# UNITED STATES PATENT AND TRADEMARK OFFICE

| APPLICATION NO. | FILING DATE | FIRST NAMED INVENTOR   | ATTORNEY DOCKET NO. | CONFIRMATION NO. |
|-----------------|-------------|------------------------|---------------------|------------------|
| 10/783,549      | 02/20/2004  | Christopher L. Johnson | 21029.29003         | 7422             |

## Office Action Summary

## DETAILED ACTION

FIG. 1

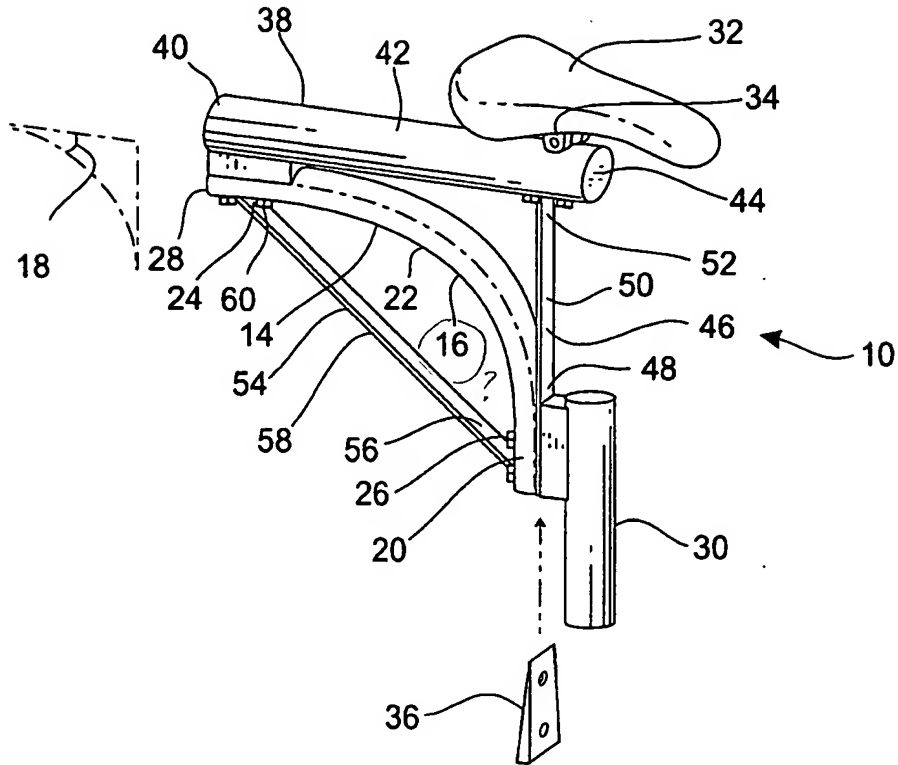
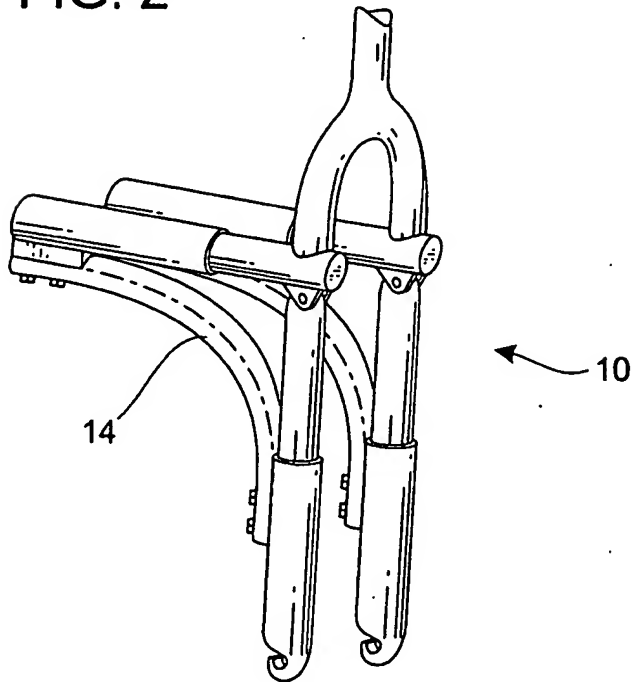
1. The drawings were received on 9/26/05. These drawings are approved.

approved  
XLW  
12/6/05
